# **ALERT SERVICE BULLETIN**

## **REPLACEMENT OF FUEL PUMP**

### **FOR ROTAX<sup>®</sup> ENGINE TYPE 912 (SERIES) SB-912-053**

(see Fig.1)

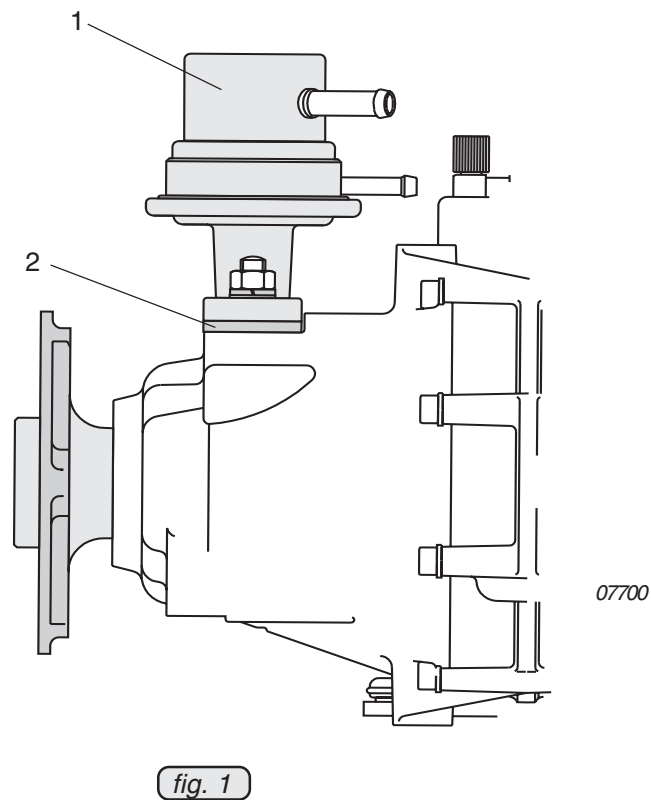
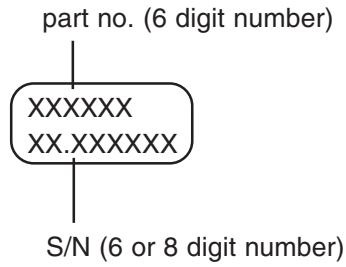
1. Remove fuel pump (1).
2. Gasket (2) replaced by new part.

■ **CAUTION:** Install new gasket supplied with new fuel pump. The thickness is different.

3. Install fuel pump. Tightening torque 15 Nm (133 in.lb).
4. Install fuel line.
